STATE OF HAWAII
 DEPARTMENT OF TRANSPORTATION
 HIGHWAYS DIVISION
SITE PLAN - 1
SITE 5 - MP 27.7
 EMERGENCY EARTHQUAKE ROCKFALL REPAIRS
 VARIOUS LOCATIONS ON HAWAII, UNIT 4
 Federal Aid Project No. ER-15(22)
 Scale: As Shown Date: December 2009
 SHEET No. G-5.1 OF 9 SHEETS

07/28/10	Added Note per Addendum 3
DATE	REVISION

STATE OF HAWAII
DEPARTMENT OF TRANSPORTATION
HIGHWAYS DIVISION
TYPICAL SECTIONS
SITE 5 - MP 27.7
EMERGENCY EARTHQUAKE ROCKFALL REPAIRS
VARIOUS LOCATIONS ON HAWAII, UNIT 4
Federal Aid Project No. ER-15(22)
Scale: As Shown Date: December 2009
SHEET No. G-5.3 OF 9 SHEETS

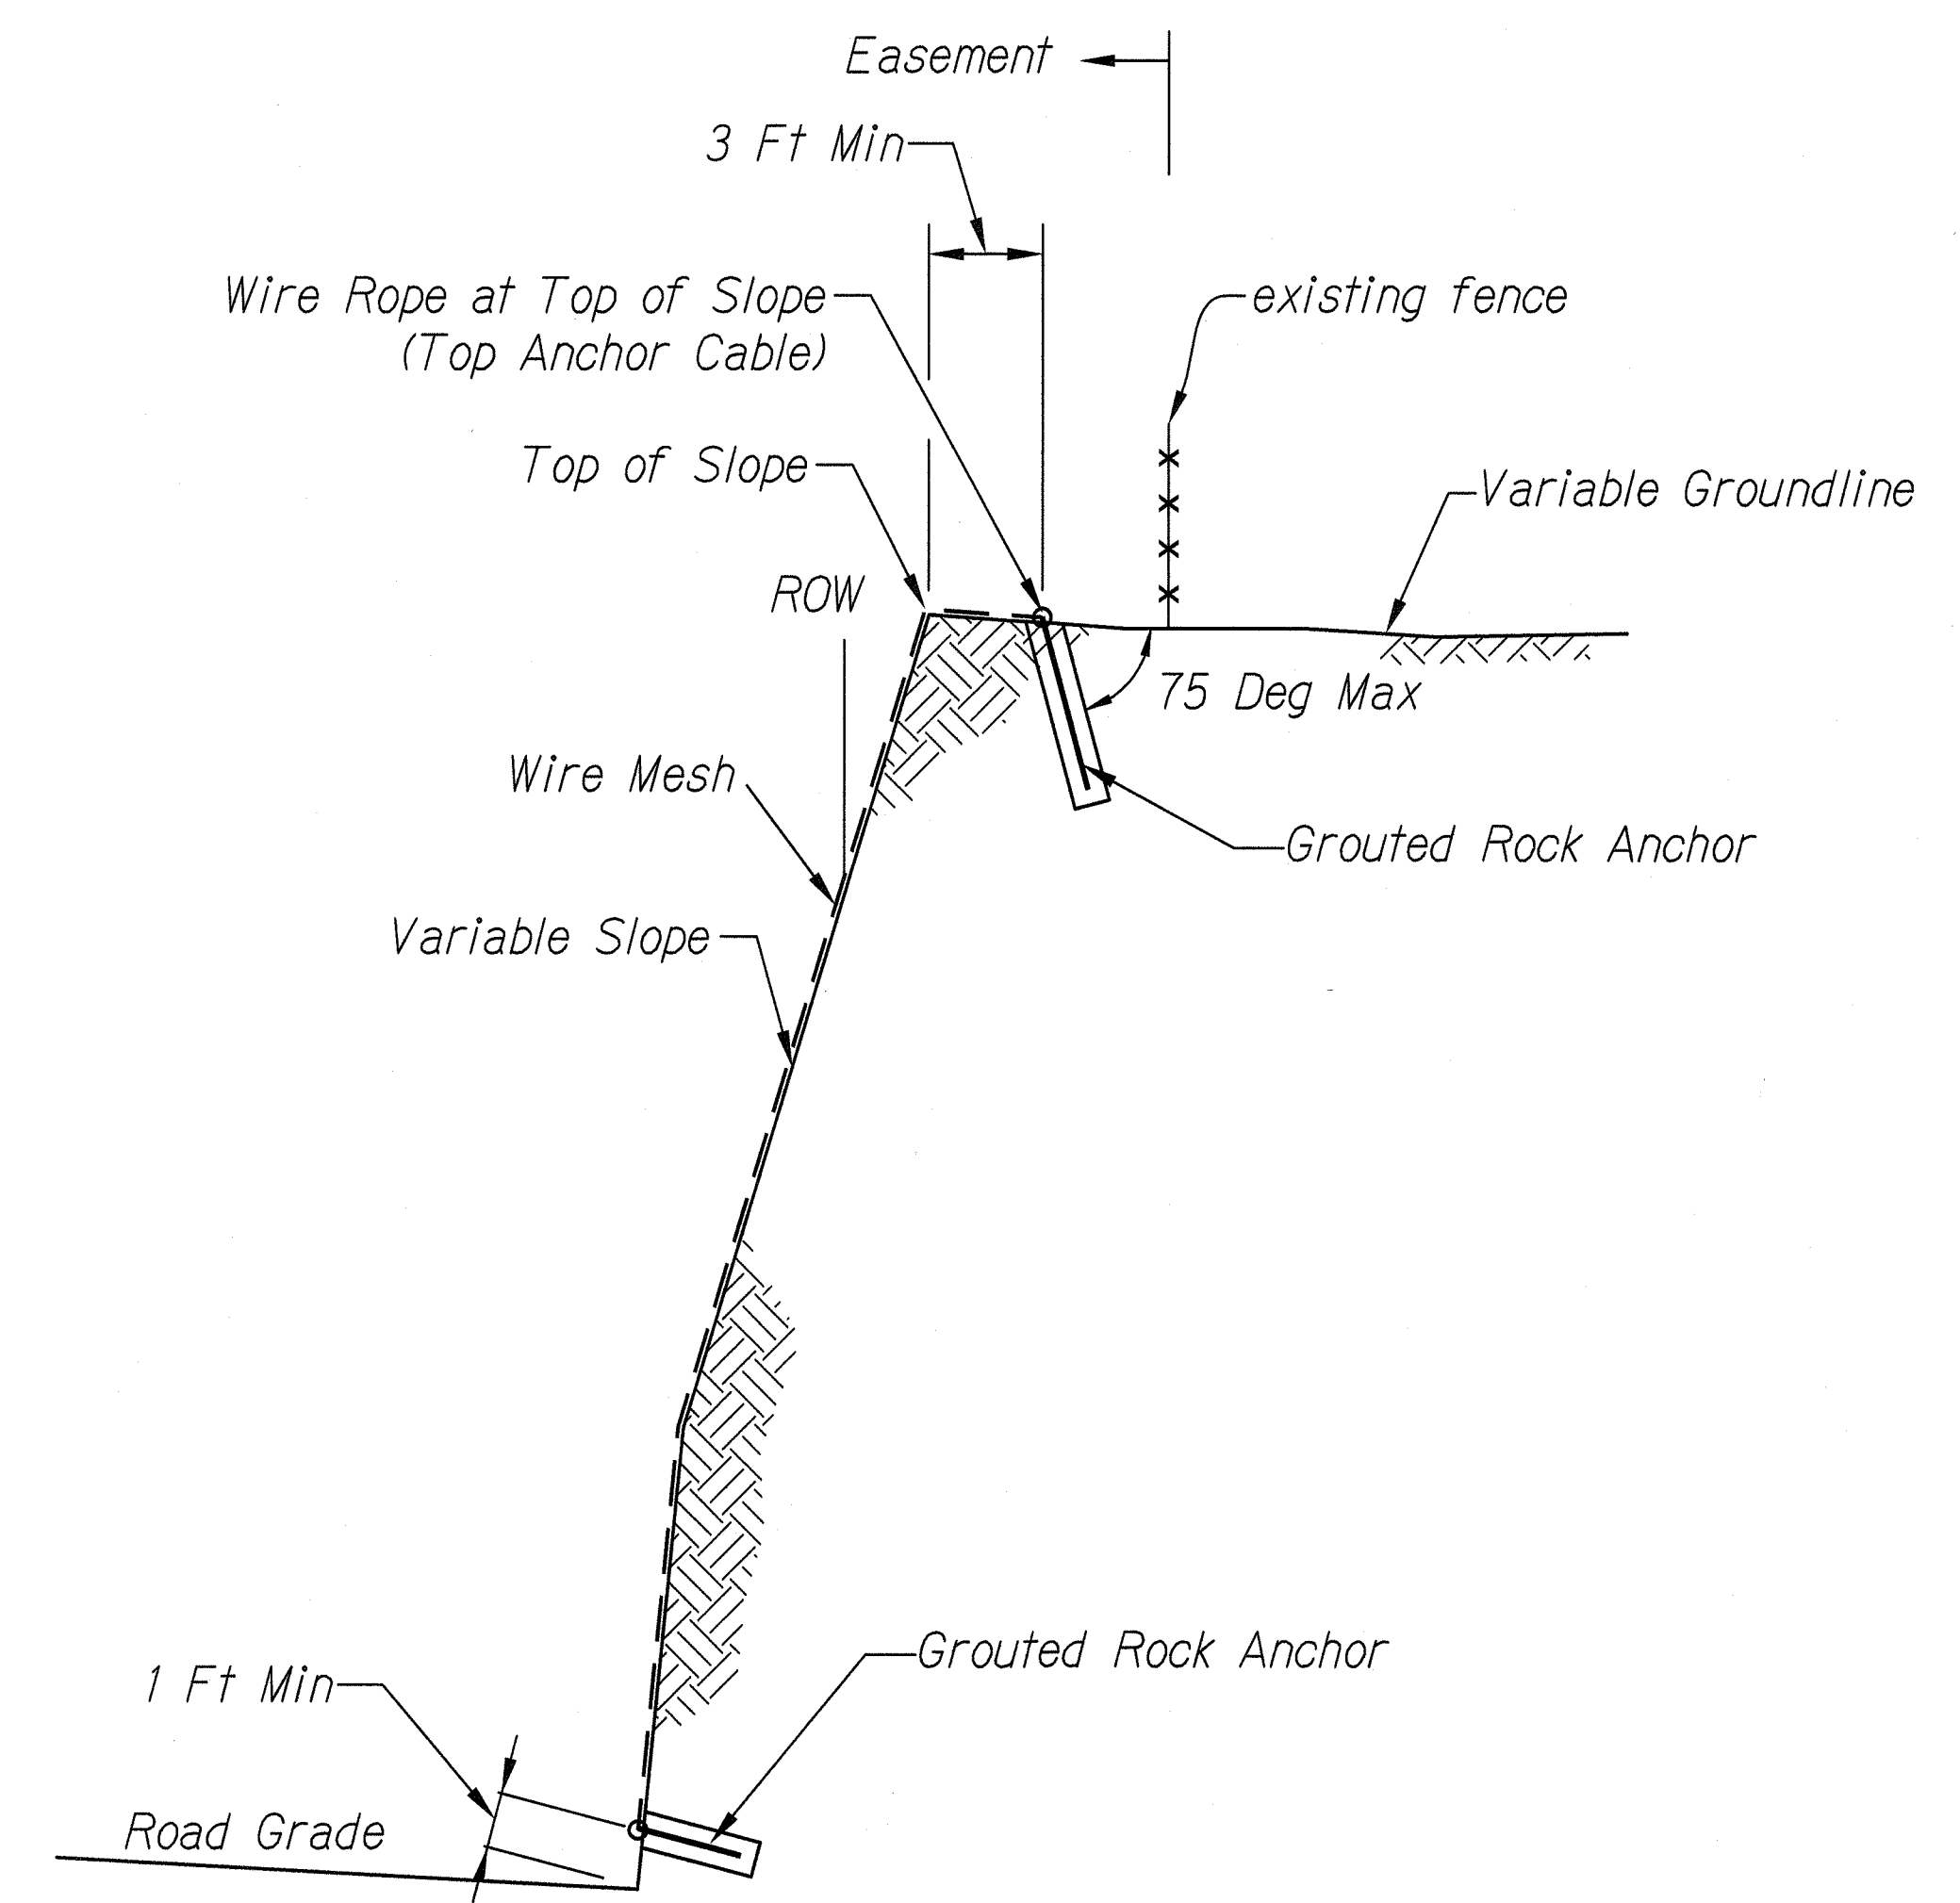
⚠ Note: If the existing fence is disturbed during construction, it shall be restored to Hualalai Corporation manager's satisfaction at no cost to the State.
